**RUBIDOUX COMMUNITY SERVICES DISTRICT
CONTRACT DOCUMENTS FOR CONSTRUCTION OF
LELAND J. THOMPSON WATER TREATMENT PLANT BACKWASH SUPPLY PIPELINE**

ADDENDUM NO. 1

DRAWING
M-1
 8 OF 10 SHEETS
 R.C.S.D. PLAN No.

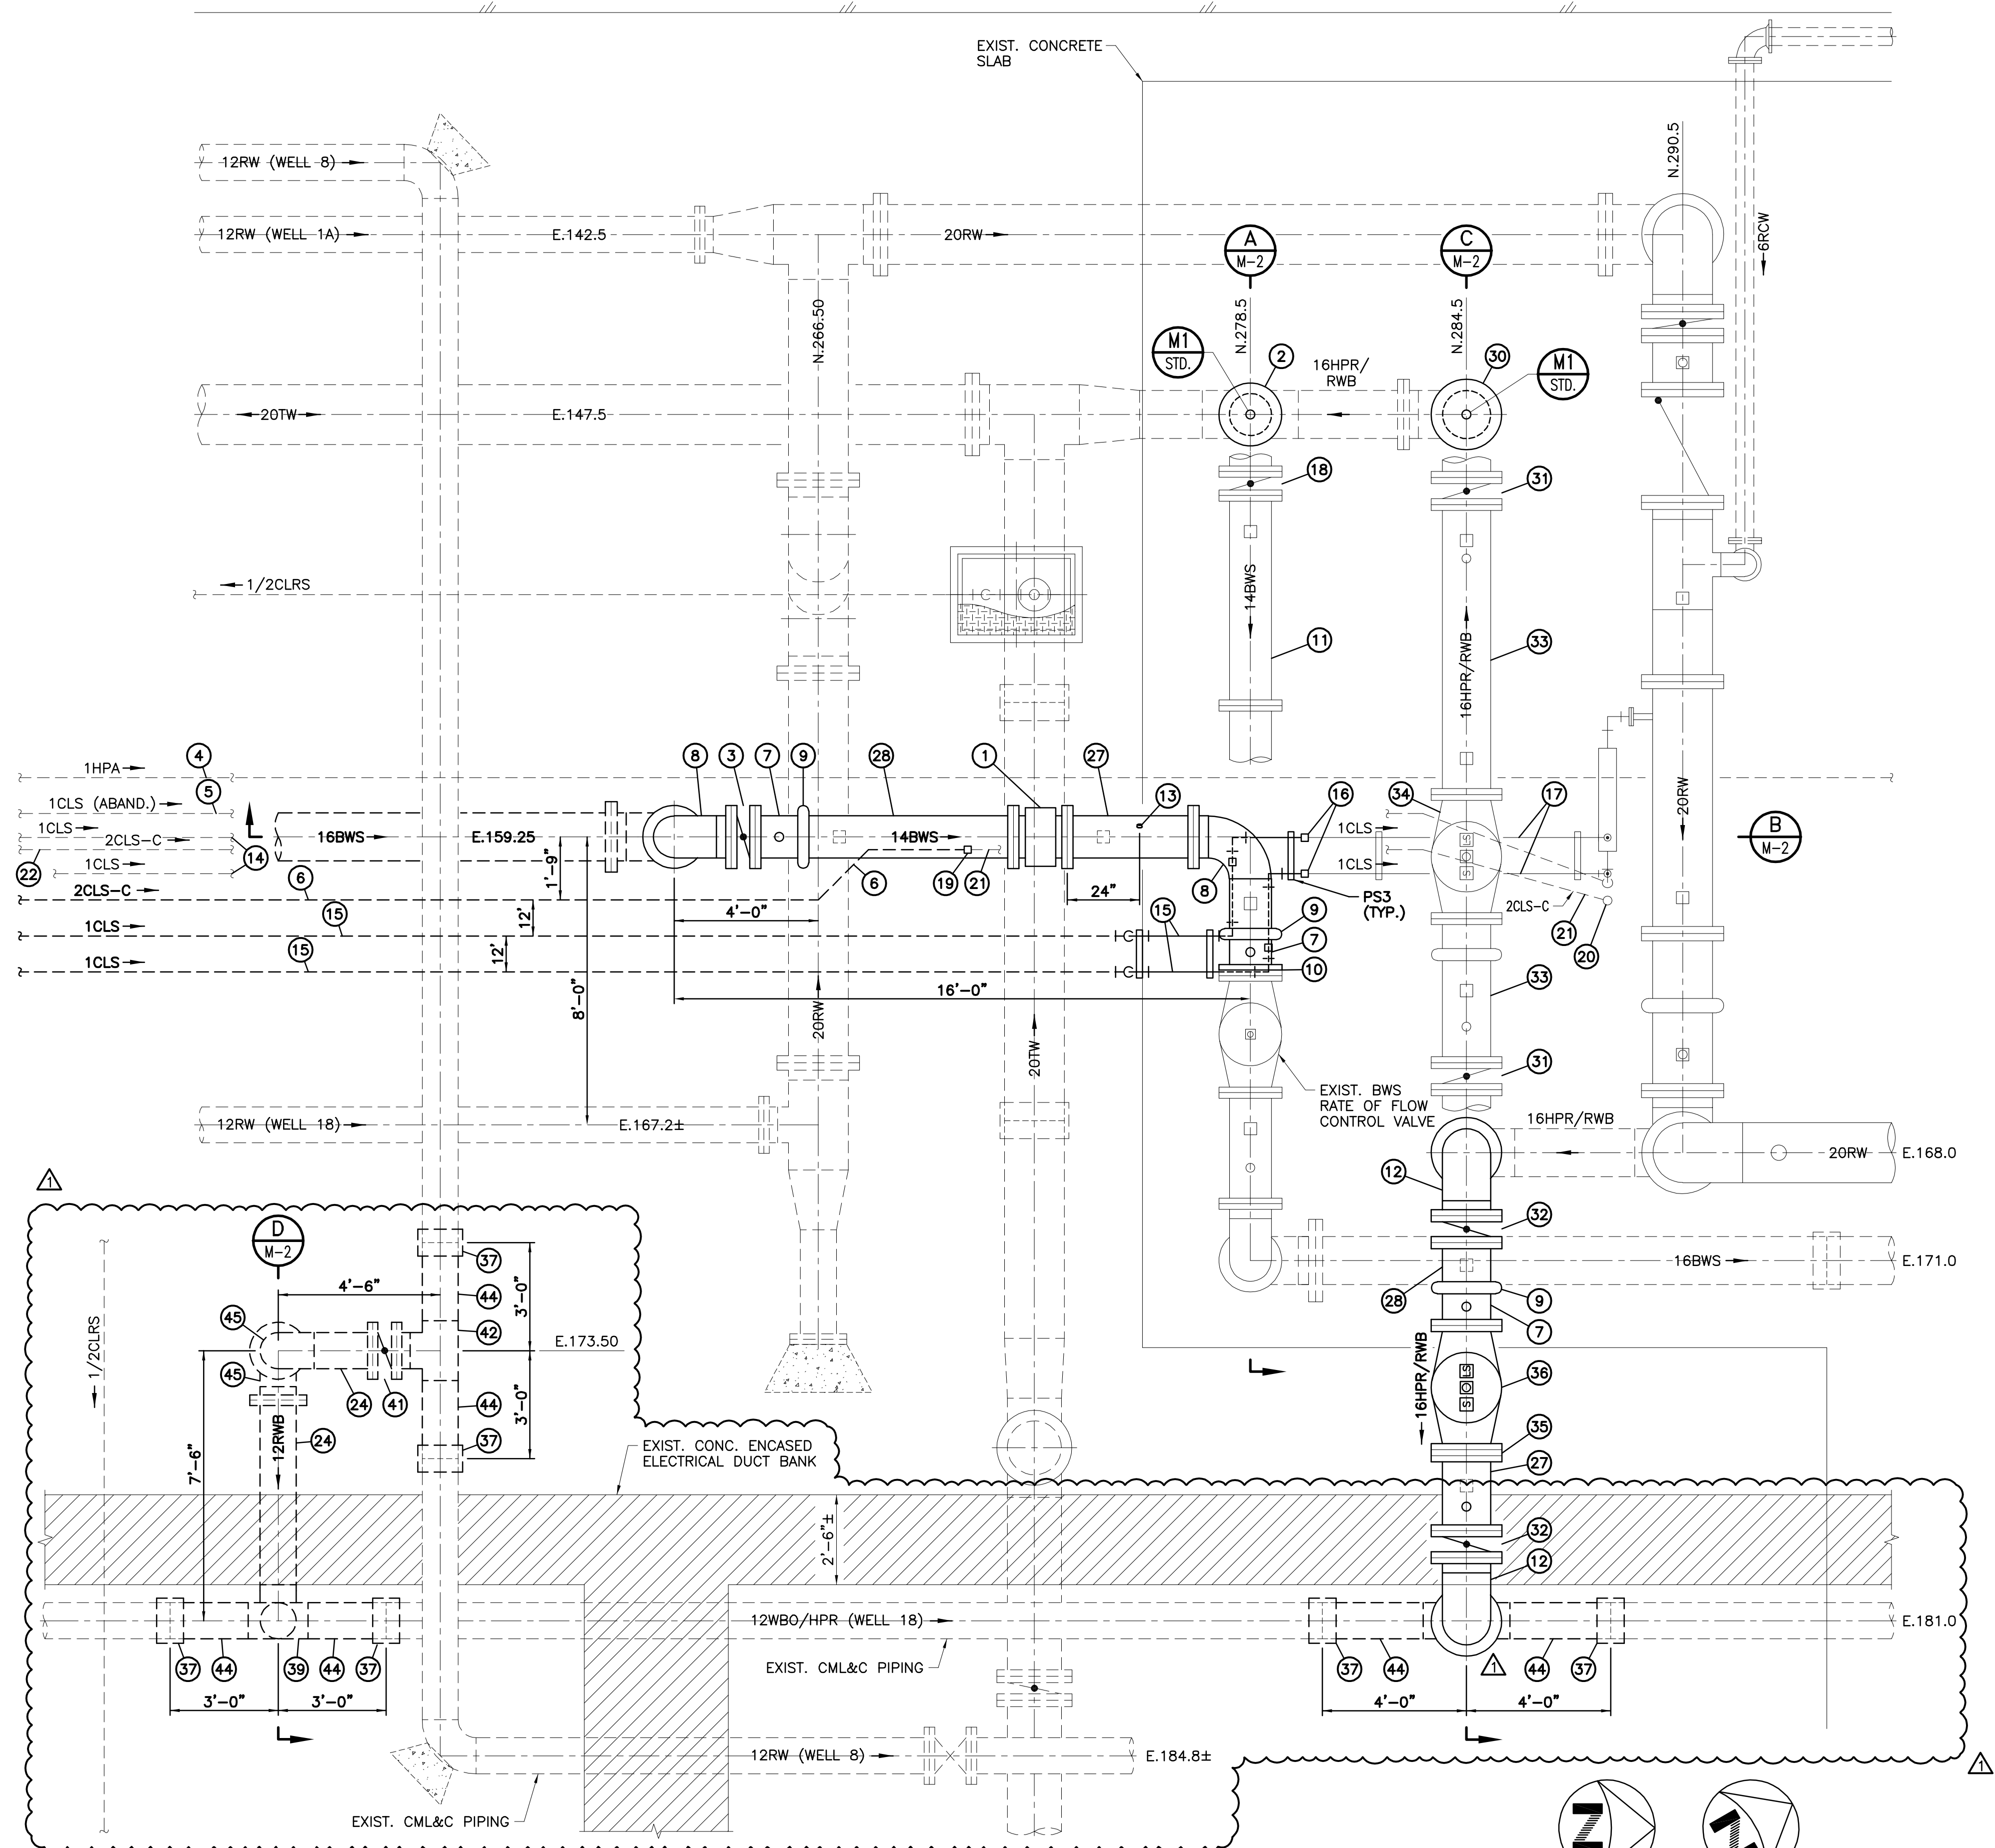
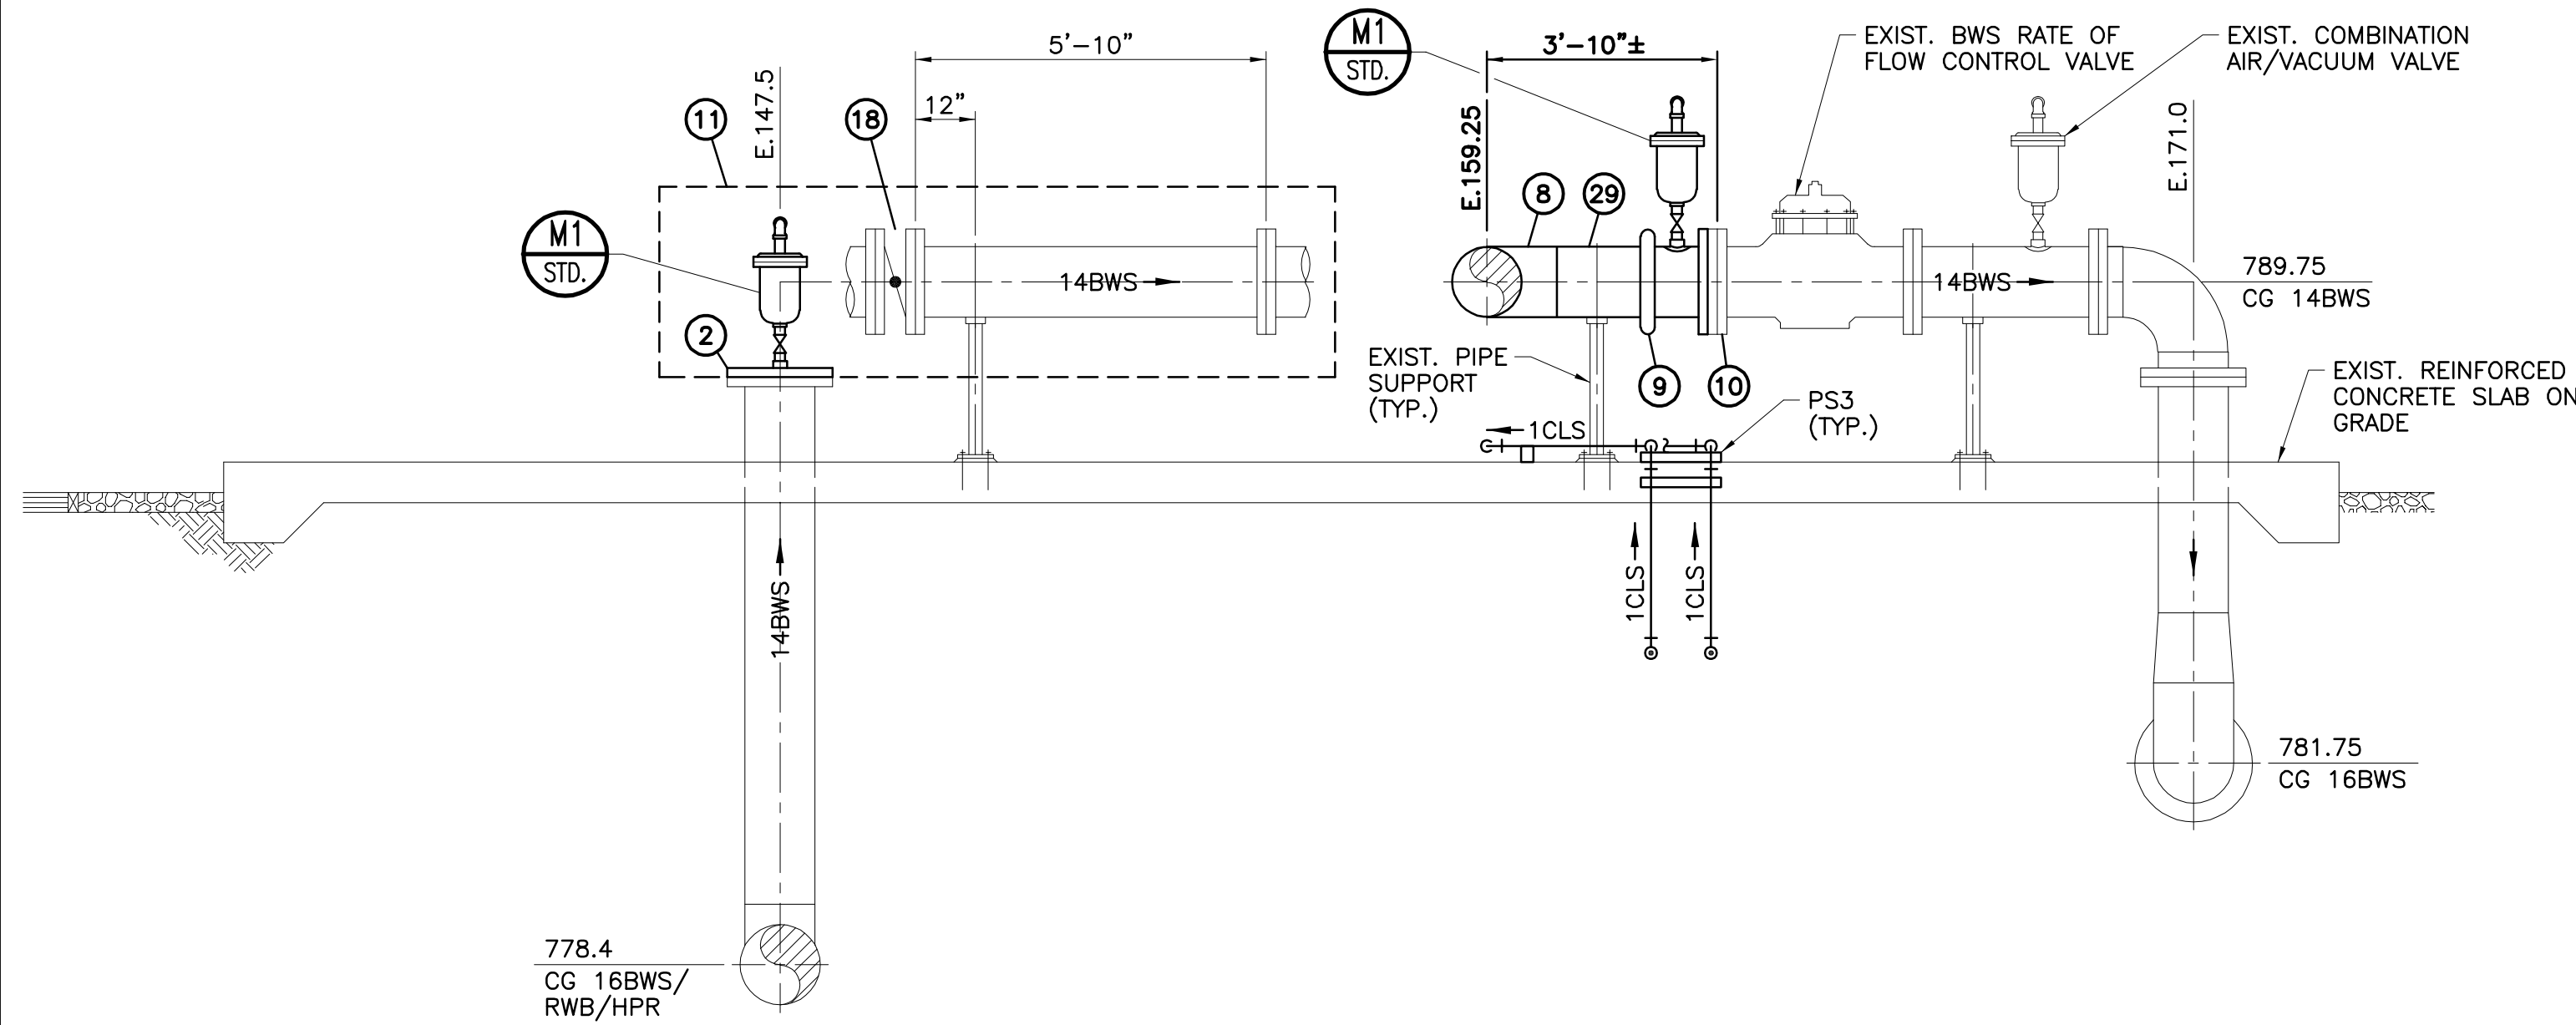
Question 13: Can we get clarity on the tubing 2CLS-C size. The plans do not call out the size of the tubing that will go inside the PVC 2" Pipe. Please advise.

Answer 13: Tubing is no longer required for the project. See Addendum Item No. 4 above and revised Construction Drawing M-1 provided with this Addendum No. 1.
